CITY OF VANCOUVER
DEVELOPMENT, BUILDINGS, & LICENSING

DEVELOPMENT PERMIT STAFF COMMITTEE
MEETING
June 8, 2022

750 Pacific Boulevard (COMPLETE APPLICATION)
DP-2021-01096 – CD-1 (349)

DEVELOPMENT PERMIT STAFF COMMITTEE RECOMMENDATION: APPROVE

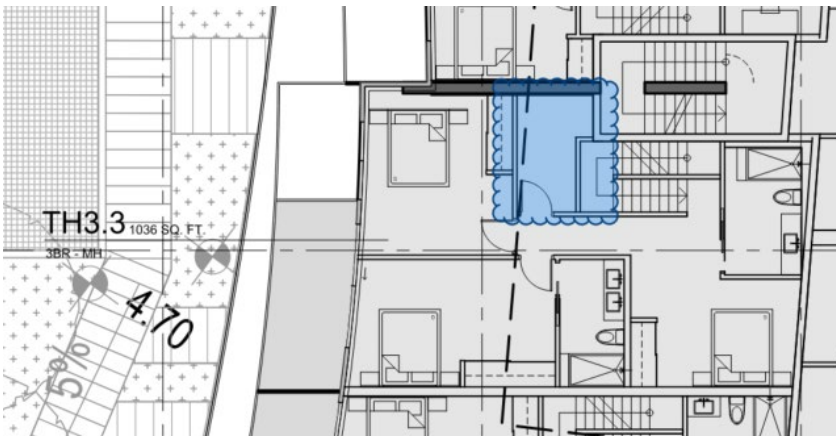
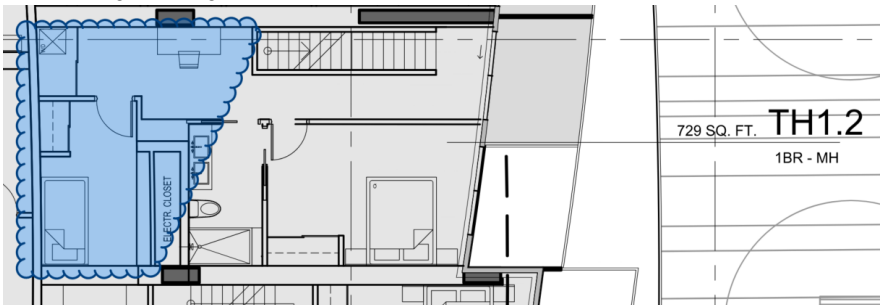
- 9A.1 dimension dwelling units to illustrate floor area size; and
- 9A.1 note only net dwelling unit size on floor plans;

Note to Applicant: Coordinate illustration and size with project data summary. Dwelling unit size are required to calculate bicycle space requirements. Future conditions may be required pending confirmation of each dwelling unit size.
